Certificate of Appropriateness

Property	2204 N. HUBBARD ST. BREWERS HILL HISTORIC DISTRICT
Description of work	Applicant proposes to re-roof using Timberline Natural Shadow shingles in Hunter Green. New half-round gutters will be installed in brown to match existing trim on the house. Valleys will be done with metal flashing. The chimney will be tuckpointed and step flashed. Downspouts will be routed away from house and neighboring houses.
Date issued	9/23/2019 PTS ID 114860 COA Re roof and gutters

2204 N Hubbard in 2015

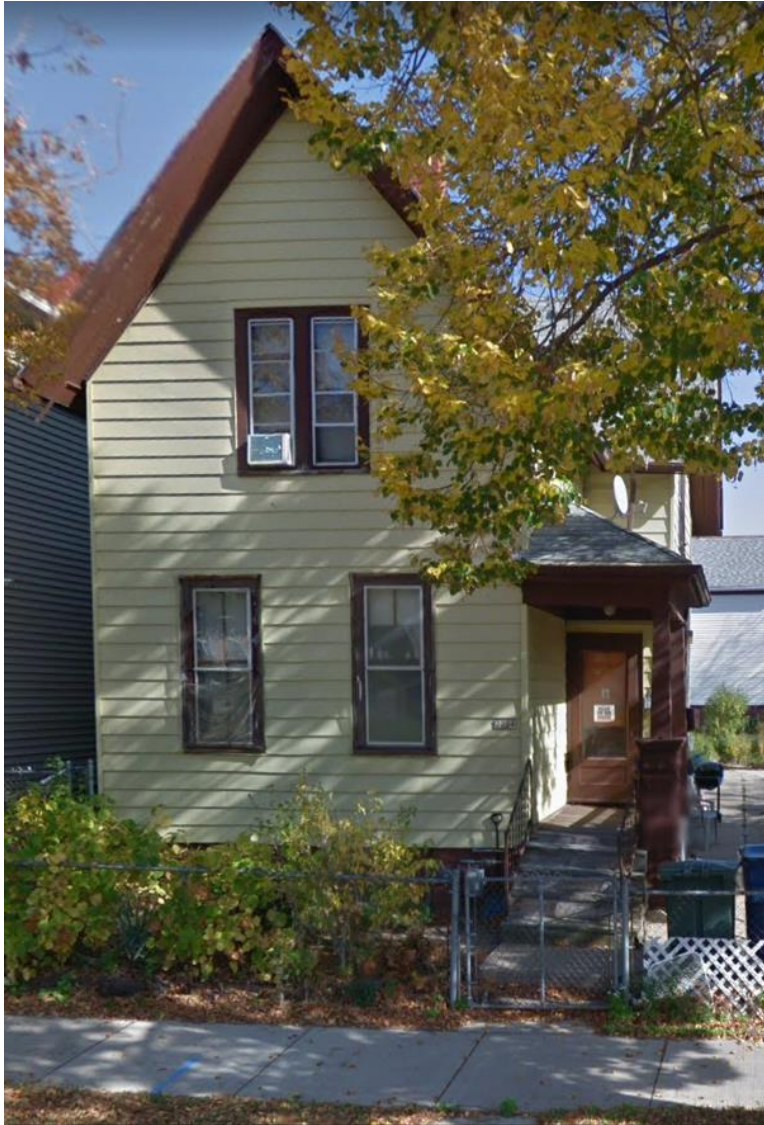
New Timberline Natural Shadow shingles to be installed, Hunter Green

Gutters to be half rounds in brown

Chimney to be step flashed and repointed with appropriate mortar as specified above

Ridge vents preferred. Pan vents if used must be on roof slopes not visible from street(s) and painted to match roof color
